The Honorable Michael Rawlings, Mayor  
City of Dallas  
City Hall  
1500 Marilla, #5EN  
Dallas, TX 75201  
RE: Trinity Parkway "Dream Team" Report Comments

RE: Forums on the Trinity Parkway "Dream Team" Report Comments

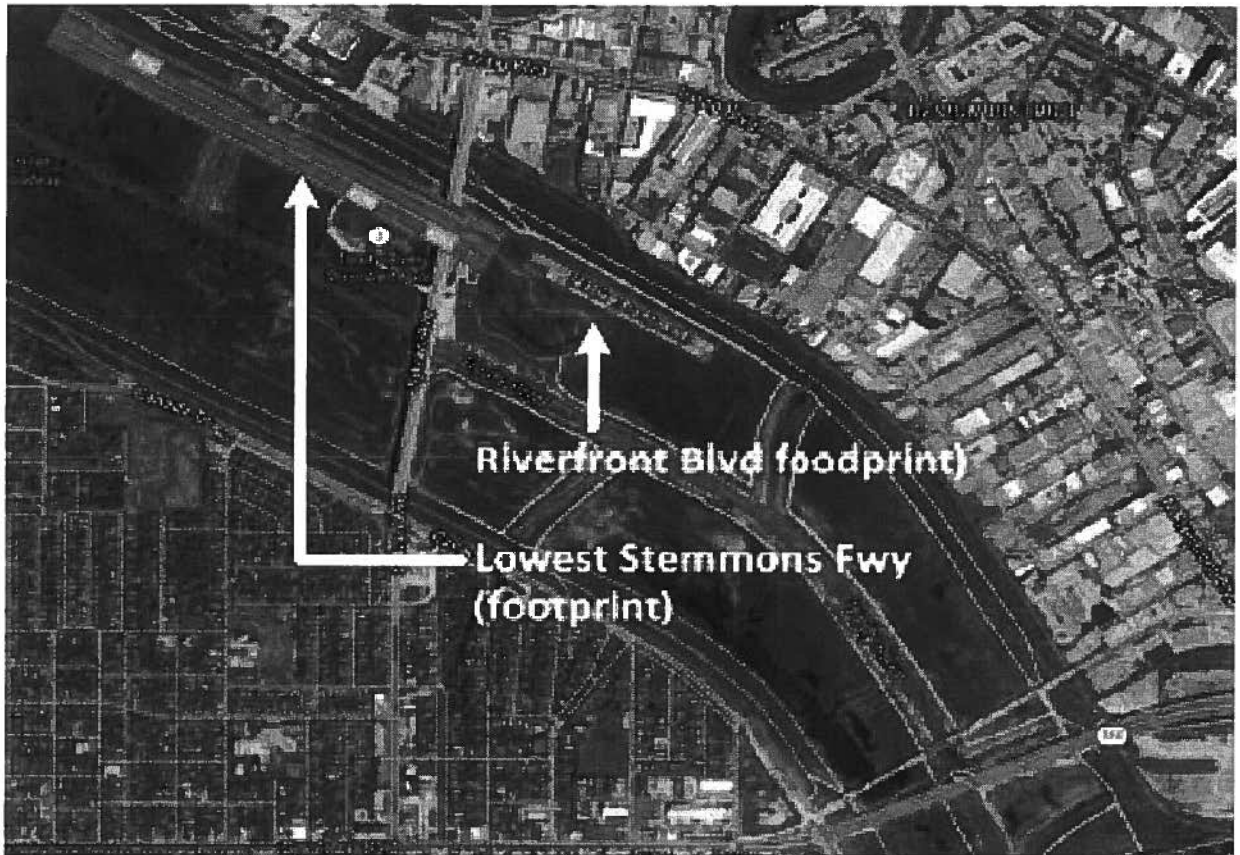
1. The width of the 3C bench as drawn on the Trinity Parkway Design Summary rendering (handed out at your meetings) seems out of scale to number of lanes the original 3C proposal was to accommodate and the EIS diagrams I reviewed. I sincerely hope that the rendering is to scale since this is a critical element for public review and comment. Given there was no scale on the rendering is difficult to judge. I did however pull an image from Google Maps of a portion of the floodway and superimposed segments from Riverfront Blvd and Lowest Stemmons approximately where the roadway appears in the City's rendering. As you can see, it seems as if the width of the bench would be more significant.

May I suggest that the furthest extent of the bench from the levee into the floodway is appropriately represented so that the public understanding where the roadway/bench end and the land available for the park begins.

**EXHIBIT A (item 1)**

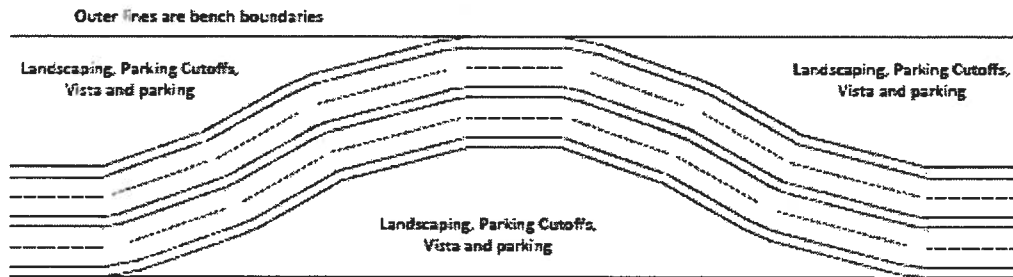
1	Only build a 4 lane roadway now – fit those 4 lanes of traffic (narrow lanes + grass shoulders) meandering within the approved road corridor.	Four (4) lanes only. The road should conceptually meander from edge to edge of the bench (see exhibit A) leaving room only for trails. The road should be banked per Beasley presentation. Meandering from edge to edge does NOT mean out of proportion straight distances to meanders. The George Washington Parkway is a good reference model.
2	Build fewer ramps, only build two sets of ramps accessing the inner city for the foreseeable future: 1 on/off pair at the north end near the Medical District and 1 on/off pair at the south end near Cedar Crest.	A maximum of TWO seems reasonable. The interchanges should be of simple diamond design as shown on the rendering. That means NO cloverleaf or flyovers.
8	Roadway and land bench elevations, roadway corridor and end connections to highways generally as earlier proposed	The recent floods clearly raises the question of the viability of any road. There is an incremental cost for both a larger and higher bench. See General comment 3.

3	Meander the parkway within the approved road corridor so that future road section can be finished now as pull-off parking areas on both sides of the Parkway – for access to the park and to the scenic overlook	See comments for point 1 and exhibit A above.
6	Pedestrian links across the parkway generally as earlier proposed – 15 links under and over the parkway at about ¼-mile intervals	Reasonable requirement. No specific comments on links
9	Top-of-levée bikeways and pedestrian paths generally as earlier proposed	Absolutely
12	Allow on-street parking along the parkway on weekend slow periods and special occasions	Yes as there will not be enough parking in pull-off parking areas.
13	Allow toll free park use from the parkway	Absolutely
15	Service roads/bikeways/pedestrian paths around the parkway generally as earlier proposed	Yes on bikeways and pedestrian paths. As an avid cyclist, I know there are lots of details for functional trails. Therefore, it's important to have the necessary experts' part of the team. Unclear on the land/space requirements for the service roads to have a judgement.

ITEM #2

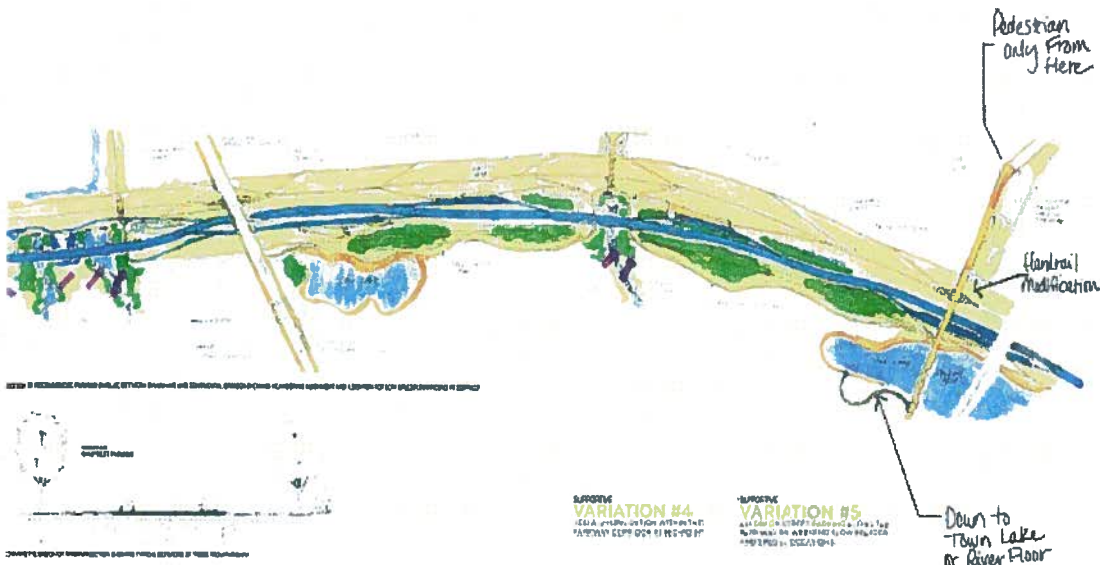
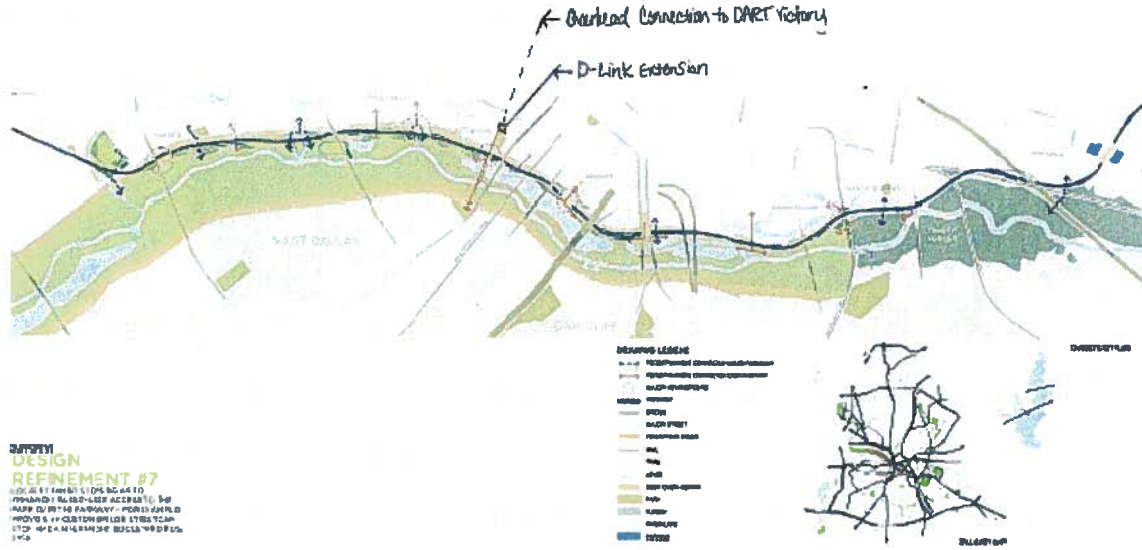
- Item #1: "The Trinity Lakes Connector With Tollway". Also shown is the proposed Trinity Tollway with Woodall Rodgers/CBD exit (full 3C size). The Dream Team's plan does not show this exit; however, if there were to be an exit midway of the Tollway, we would like to see it one lane North and one lane South and we would like to see if it be accomplished within the existing right-of-way. The actual Trinity Lakes Connector (elevated) is not necessary if the handrails to the Continental Pedestrian Bridge are to be modified to access the Levy Top Trail as shown in Item #3.

- Item #1 Concerns: Sound
- Item #2: The proposed Parkhouse Trail without the Tollway. If the Continental Pedestrian Bridge needed to be "extended" to make way for the Woodall Rodgers/CBD exit, then a combination of the Rail Modifications in Item #3, and the Parkhouse Trail, could be used as a bypass to facilitate the construction/extension. After the Bridge reconstruction, the Parkhouse Trail could close.

- Item #2 Concerns: We are opposed to any cars on top of the Pedestrian Bridge – whether rebuilt or not – from Canada Drive to the bollards at Core Street (as shown on Item #3).

- Item #3: We are very much in favor of the ramp down from the Continental Pedestrian Bridge to the "Town Lake" or river floor.
  - Item #3 Concerns: We believe the existing power circuit at the east end of the Continental Bridge could be a potential safety hazard (not shown).

- Item #4: Shows the connections over the Parkway. We believe that long-term some type of an overhead connection between the Continental Bridge and the DART Victory Station would greatly benefit the area. It is shown on Item #4. We believe that short-term this could be accomplished by extending the existing D-Link (Route 722) in the West End over to the bollards at the Continental Pedestrian Bridge. With this extension, we open up the possibility for a person from North Oak Cliff, without a car, to access the world through the DART Victory/DFW Airport connection.
